This article supersedes TSB **13-12-21** to update the vehicle application.

ISSUE

Some 2011 and 2012 Explorer, Taurus, Flex, MKS and MKT vehicles built on or after 9/1/2010 and equipped with dual engine cooling fans may exhibit a lack of air conditioning (AC) performance while the vehicle is stationary or moving at slow speeds, and/or an overheat condition. Diagnostic trouble codes (DTCs) P0217, P1299 and P1285 may be present.

Figure 1 - Article 14-0019

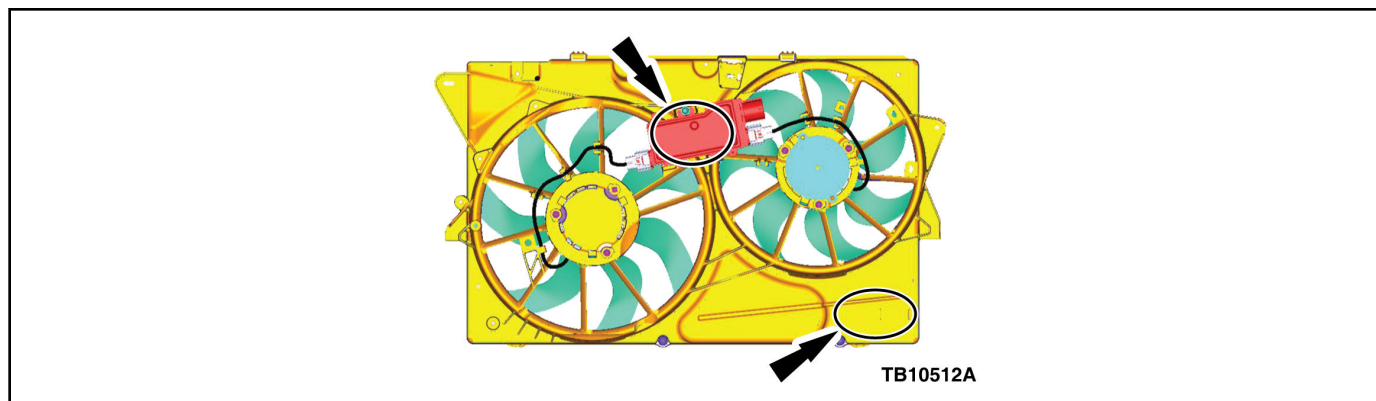
- a. No – please be sure to check the fan assembly for being original equipment manufacturer (OEM). (Figure 1)

- (1) For Taurus and MKS vehicles, replace the cooling fan motor and control module assembly. Refer to Workshop Manual (WSM), Section 303-03 and then proceed to Step 5.
 - (2) For Explorer, Flex and MKT vehicles, proceed to Step 3.
- b. Yes - this article does not apply. Refer to WSM, Section 303-03 for normal diagnostics.
3. Remove the cooling fan motor and control module assembly. Refer to WSM, Section 303-03.
 4. Remove the cooling fan control module from the original cooling fan motor assembly and transfer onto the new cooling fan motor assembly. Tighten screw to 7 Nm (60 lb-in).
 5. Install the new cooling fan motor assembly. Refer to WSM, Section 303-03.
 6. Check coolant level and top off as necessary using the correct coolant type. Refer to WSM, Section 303-03.
